## FIELD SERVICE BULLETIN

FSB Number: LVCCFSB2006 - 159  
Author: Eduardo Rodriguez  
Date: April 14, 2006  
Total No. of Pages: 4  
Subject: **3G V3x – Hall Effect Switch Sensitivity**  
Phone Models: 3G V3x  
Level of Repair: 2

Fig. 5 Locations of Screws

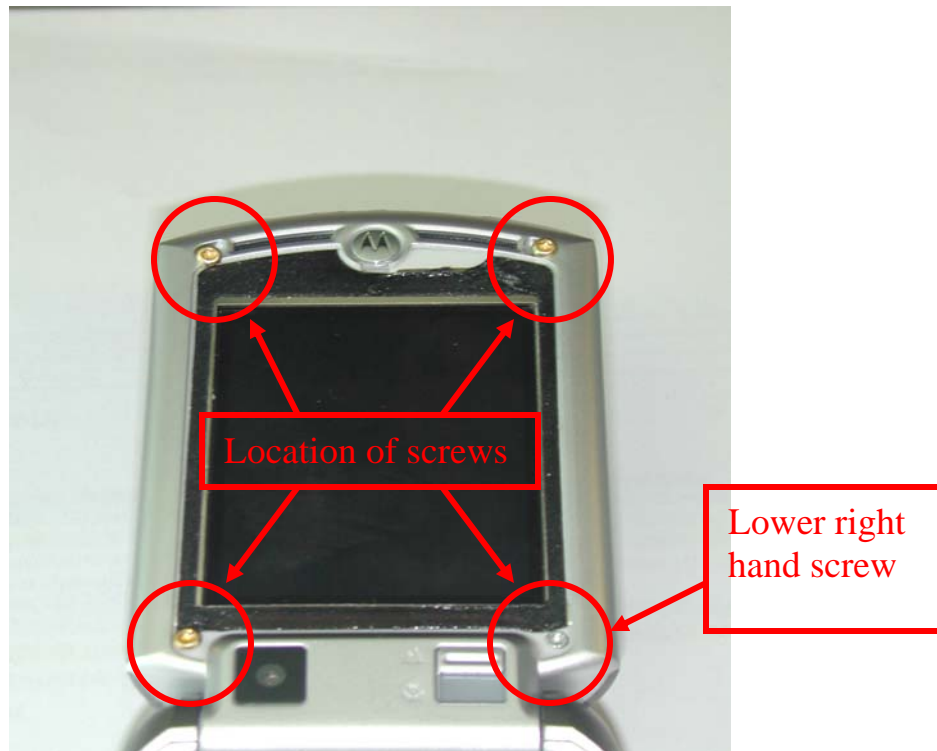
Service is aware of an issue, identified during the V3x NPI returns. Customer returned units with complaints of “CLI Backlight not working”, “Intermittent CLI Display”, and “Dropped Calls While Opening the Flip.” Analysis revealed one of the flip screws, located precisely above the hall-effect sensor, deforms the flux field around the magnet and decreases the ability of the hall-effect sensor to detect the magnet. This in turn prevents the CLI display from working properly when closing, moving or shifting the flip assembly. On failed units, at approx. 10° (before closing flip), the backlight turned off and the wallpaper changed to carrier logo (barely visible), see fig 1, 2 and 3.

Change all four (4) screws from Ferro-magnetic steel to stainless steel 0387726M12, see fig 5.

Modified Flip Inner Housing to move magnet in the Z direction by increasing the gap in the Z by 0.9 mm (see Flip Inner Housing 1571165C01 revision F) as of 3/6/2006.

1. Verify issue by closing the flip, applying pressure to the sideways of flip assembly, shifting or moving it sideways, see figs 1 - 3.
2. If issue is duplicated, replace the lower right hand screw on units manufactured prior 2/1/2006, see fig 5.
3. Upon changing the screw, verify issue does not re-occur.

**Note: When Servicing the Flip Assembly, replace all four (4) screw from Ferro-magnetic steel to stainless steel PN 0387726M12.**

Verify V3x inventory prior 2/1/2006 and replace the Ferro-magnetic steel screw with stainless steel 0387726M12, see fig 5.
